Product Change Notification

ENCODERS

September, 2014

Model 3315 Epoxy Process and Material Change

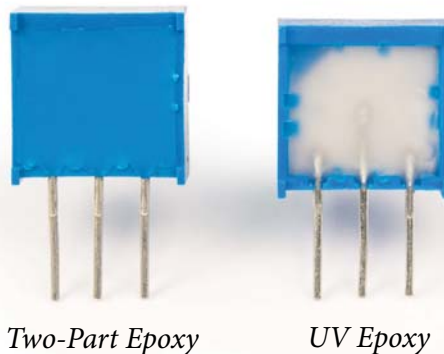
In line with our commitment for continuous improvement of our products and processes, Bourns Sensors and Controls announces a process and material change to our [Model 3315](#) 9 mm Rotary Encoder. The change involves replacing the blue two-part epoxy with a clear UV epoxy. The advantages of utilizing the UV epoxy are three-fold:

1. Elimination of antimony that is present in the two-part epoxy
2. Elimination of epoxy run-in associated with the two-part epoxy cure process
3. Provides a cleaner process in production with reduced cure time

This change does not affect fit or function of the encoder. The Model 3315 with UV epoxy has been fully qualified and meets our published performance specifications. The photo below shows samples of the Model 3315 with blue two-part epoxy and clear UV epoxy rear seals.

The epoxy change was phased in for the Model 3315 during Q4-2013. All orders are now shipping with the clear UV epoxy. Unless otherwise noted, this change was made on all standard catalog and customer-specific part numbers. Affected part numbers appear on the following page.
